Steve Morley
Vice President
Farley Project

Docket Numbers: 50-348
50-364

10 CFR 50.90

Joseph M. Farley Nuclear Plant
Steam Generator Replacement Related Technical Specifications Change Request

Figure 3.4.16-1 (page 1 of 1)
DOSE EQUIVALENT I-131 Primary Coolant Specific Activity Limit Versus
Percent of RATED THERMAL POWER with the Primary Coolant Specific
Activity $> 0.15 \mu\text{Ci/gram Dose Equivalent I-131}$

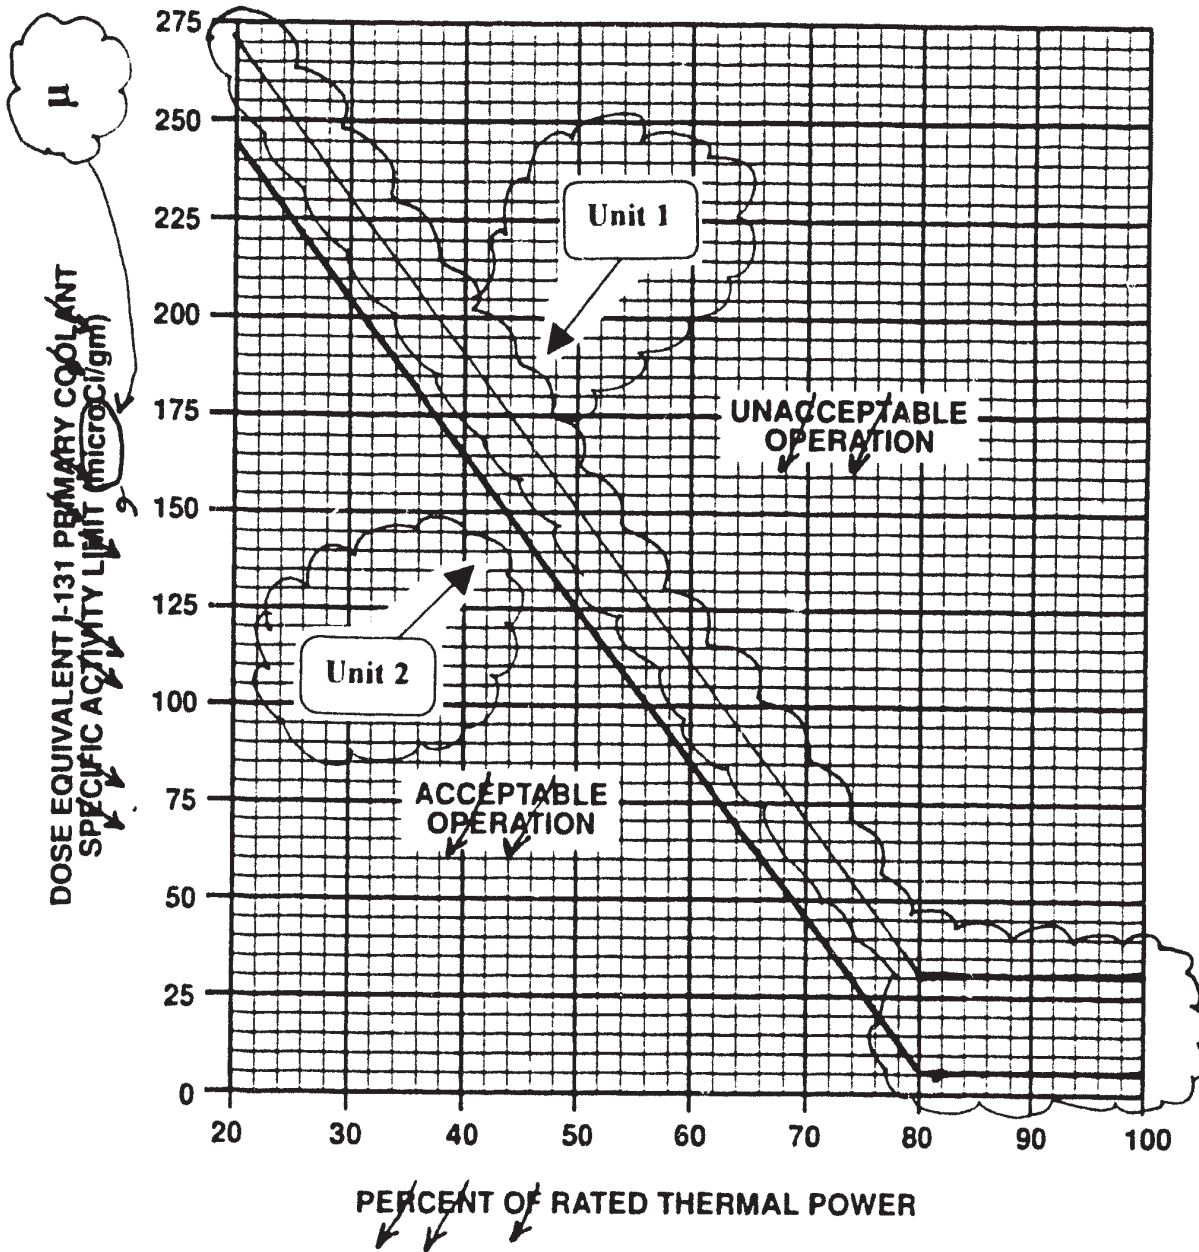
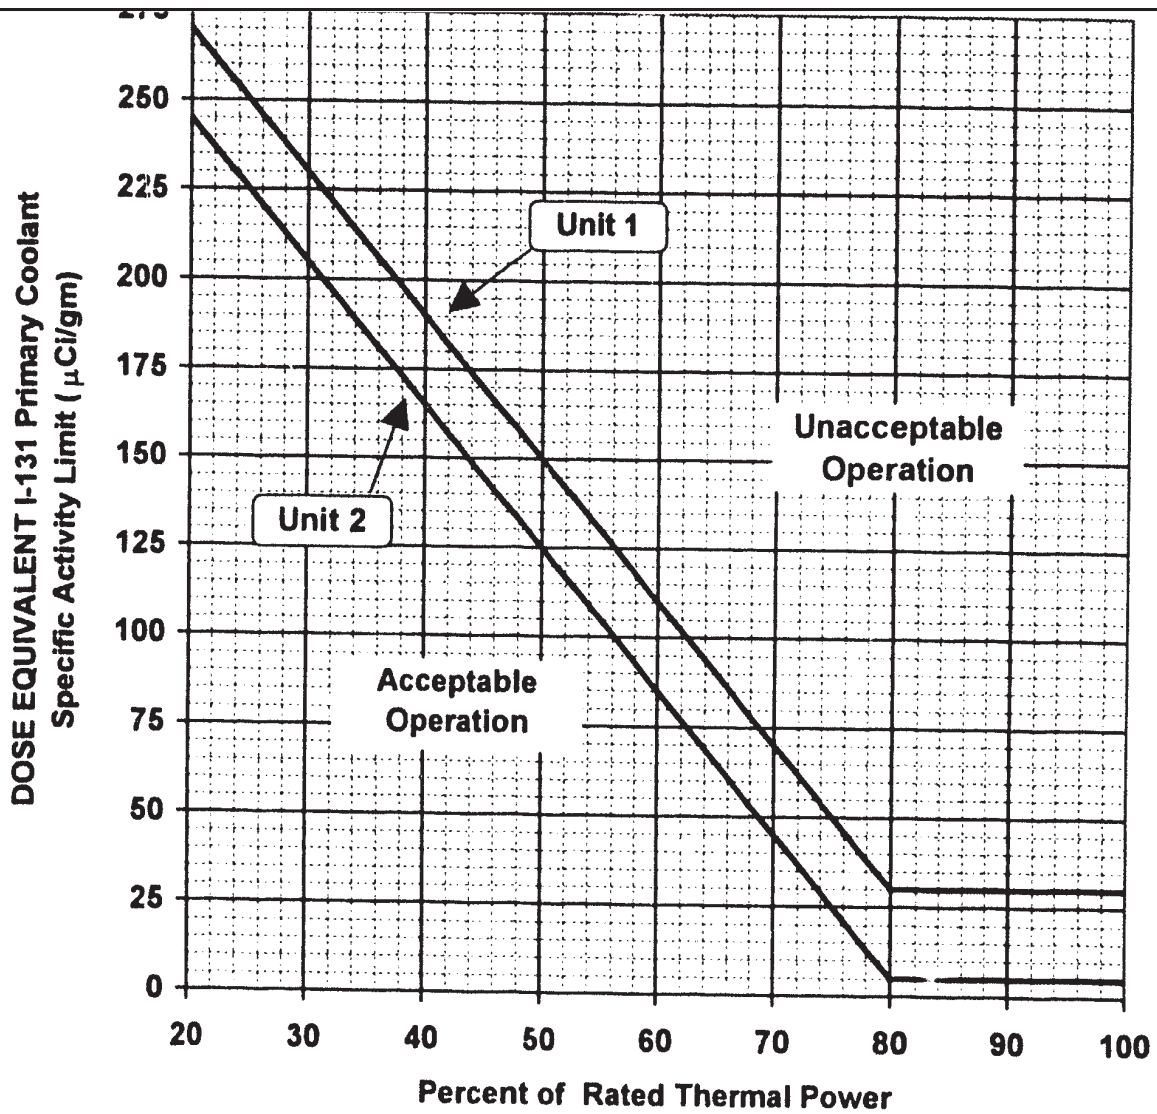
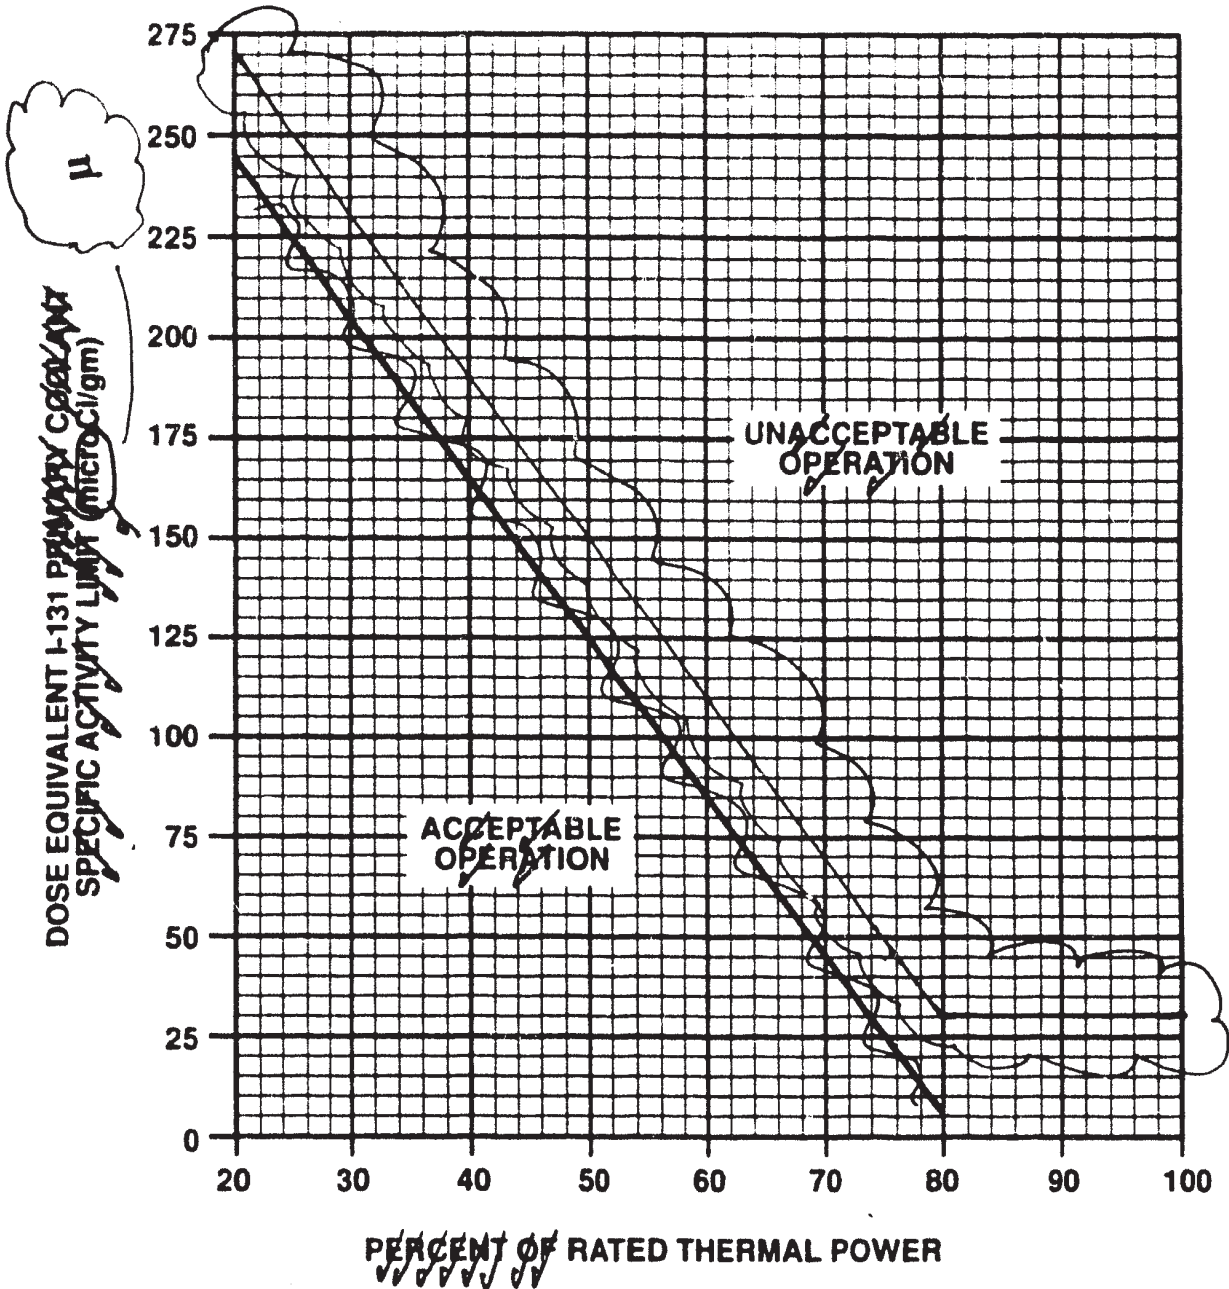
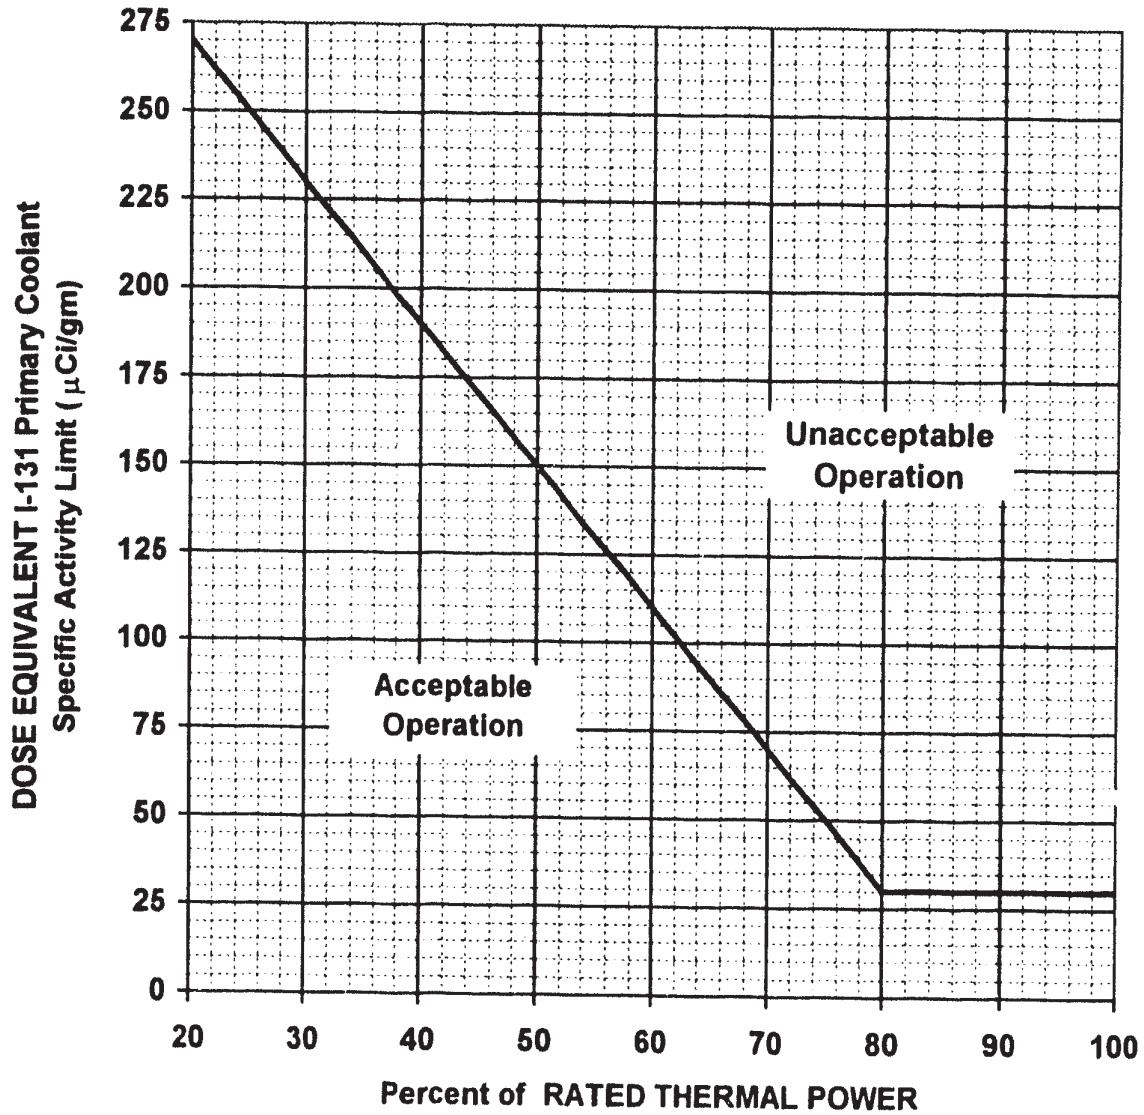
3.4.16 Fig. 3.4.16-1 B 3.4.16 B 3.7.16	Change RCS Specific Activity DEI from 0.15 to 0.5 $\mu\text{Ci/gm}$.	Radiological analysis performed for RSG used a value of 1.0 $\mu\text{Ci/gm}$, and the accident analyses results (doses) demonstrate doses do not exceed the limits.

RCS Specific Activity (3.4.16, B 3.4.16 and Figure 3.4.16-1)

The RCS Specific Activity limit was adjusted from 0.15 to 0.5 $\mu\text{Ci/gm}$. The new activity value is reflected in the revised curve for RCS Specific Activity vs Percent of Rated Thermal Power, shown in Figure 3.4.16-1. Radiological analyses performed for steam generator replacement use a value of 1.0 $\mu\text{Ci/gm}$ RCS Specific Activity and 1 gpm (1440 gpd) RCS Operational Leakage for SGs, thus bounding the Technical Specifications limits. The calculated offsite doses continue to meet the acceptance criteria of NUREG-0800. The increase in allowable RCS specific activity is acceptable based on the removal of the voltage-based alternate repair criteria. The value of 0.5 $\mu\text{Ci/gm}$ is well within established industry guidelines and below the original FNP value of 1.0 $\mu\text{Ci/gm}$. Dose analyses provide acceptable results using 1.0 $\mu\text{Ci/gm}$, and thus the value of 0.5 $\mu\text{Ci/gm}$ as the RCS Specific Activity limit provides additional conservatism. The Bases have been revised to reflect these proposed changes based on FNP specific calculation assumptions and analyses results.

3.4.16	RCS Specific Activity	DEI limit 0.5 $\mu\text{Ci/gm}$
Figure 3.4.16-1	DEI vs RTP	Revised curve based on DEI of 0.5 $\mu\text{Ci/gm}$
B 3.4.16	RCS Specific Activity	Safety analyses conservatively assume 1440 gpd and 1.0 $\mu\text{Ci/gm}$
B 3.7.16	Secondary Specific Activity	Reflects changes to RCS activity and leakage assumptions
